National Committee on Uniform Traffic Control Devices

NCUTCD Approved Changes to the Manual on Uniform Traffic Control Devices

TECHNICAL COMMITTEE: Signals Technical Committee
ITEM NUMBER: 19B-SIG-03
TOPIC: Pedestrian Pushbutton Locations
ORIGIN OF REQUEST: Signals Technical Committee
AFFECTED SECTIONS OF MUTCD: 4I.06 Pedestrian Detectors

Figure 4I-X. Pushbutton Location Area

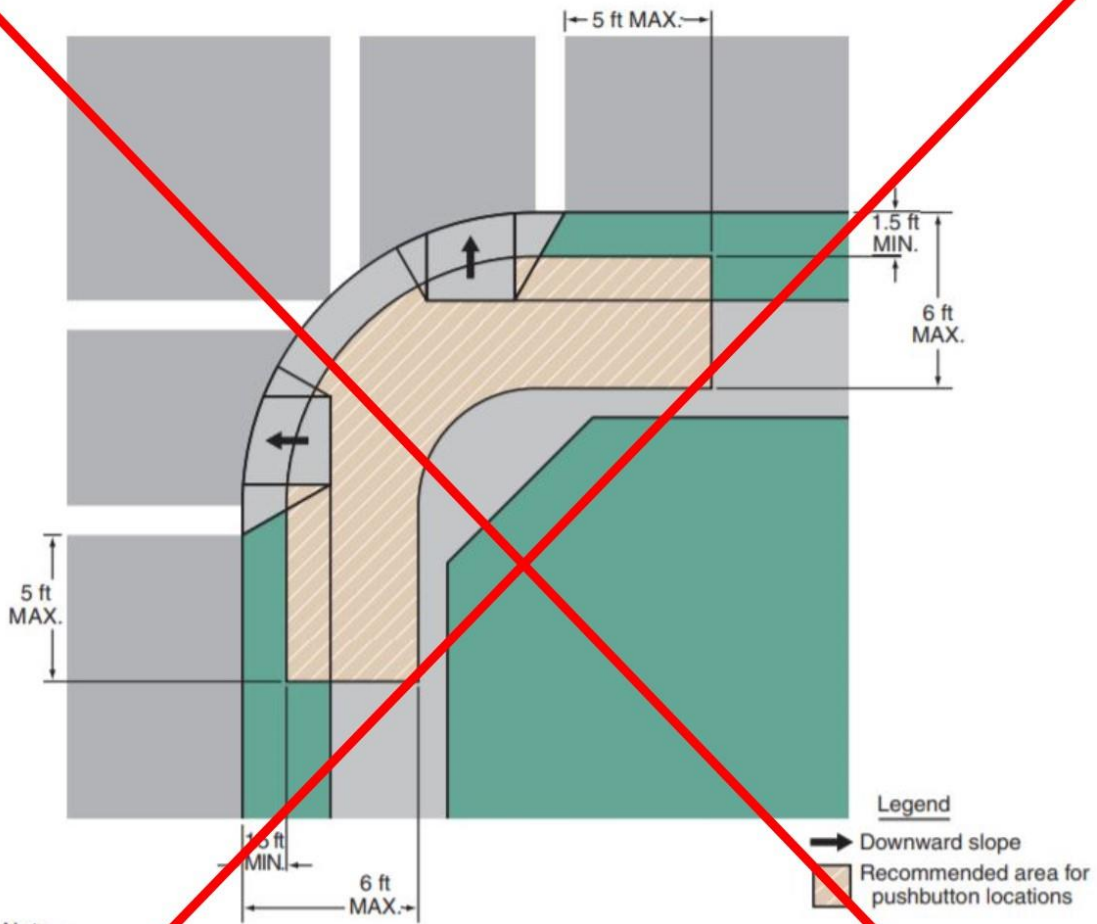
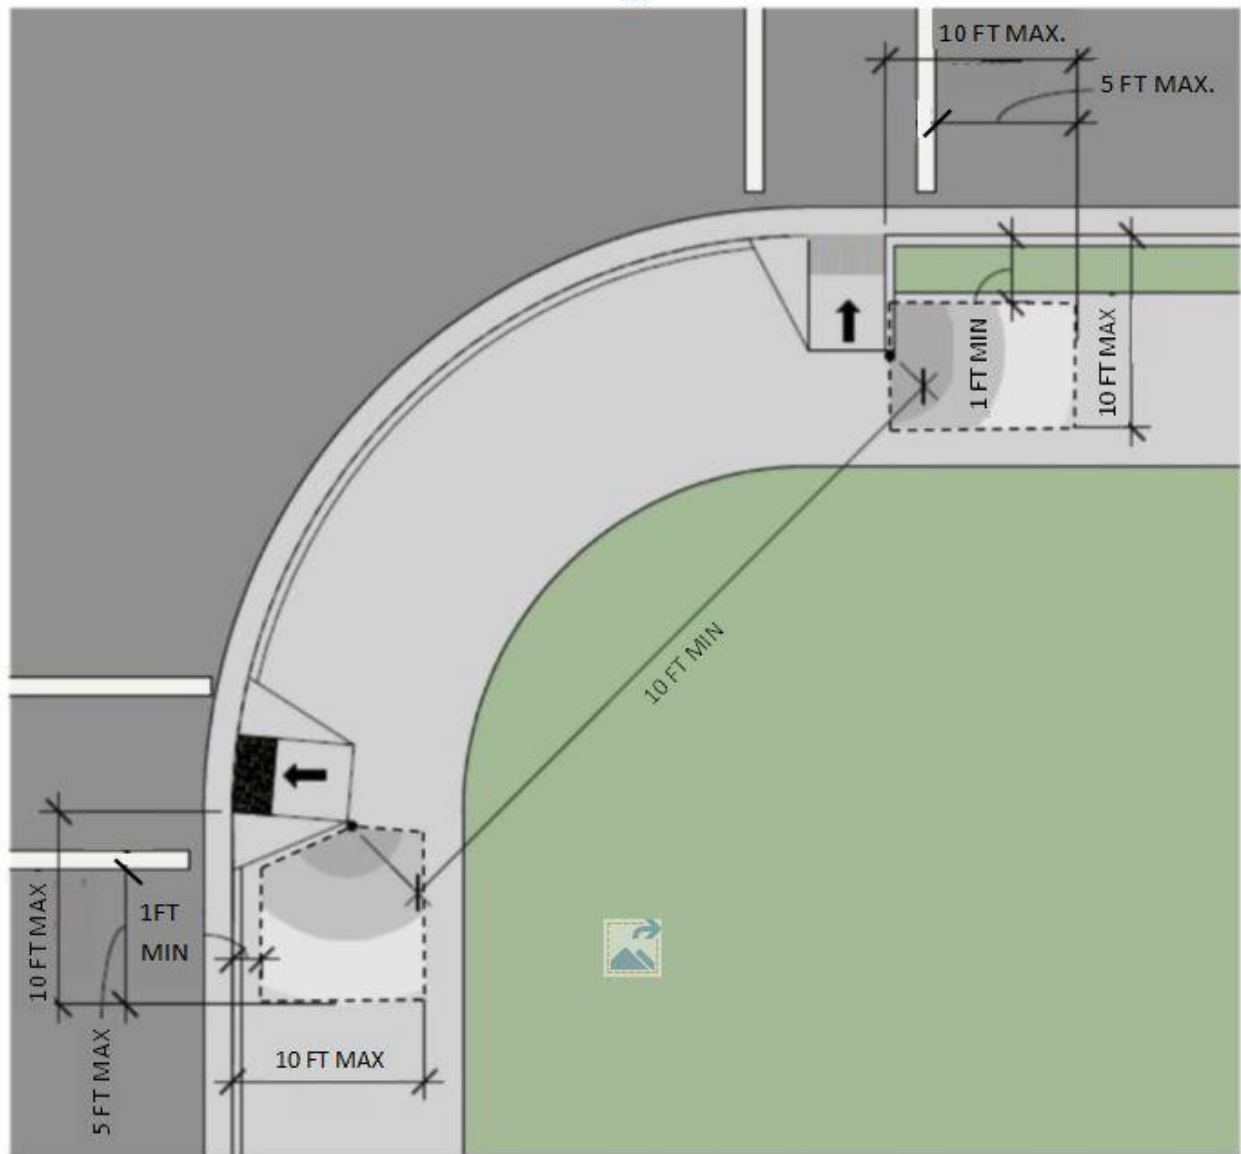
Provisions for pedestrian detectors were reviewed with respect to updating guidelines to better reflect accessibility needs. There are ideal locations for the placement of pedestrian detectors to serve accessibility needs. However, field conditions do not always allow for the optimal placement. Accordingly, revised language is proposed which would clarify optimal placement of pedestrian detectors while allowing for defined flexibility and latitude, where necessary, to accommodate unique conditions for a given location. These revisions are shown in a revised Figure 4I-X, formerly Figure 4E-3.

[Figure 4E-3 to be replaced with Figure 4I-X]

1. [No greater than 5 feet from the outside edge of the marked crosswalk farthest from the intersection.](#)
2. [Not farther from the crosswalk than the stop line, if present.](#)
3. Any maximum (MAX) or minimum (MIN) dimensions shown are based on Guidance Statements.
4. Two pedestrian pushbuttons on a corner should be separated by [a minimum of 10 feet](#). The 10-foot dimension shown in this figure is in reference to the [placement of the pushbuttons within their respective](#) areas.
5. Figure [4I-4](#) ~~4E-4~~ shows typical pushbutton locations.
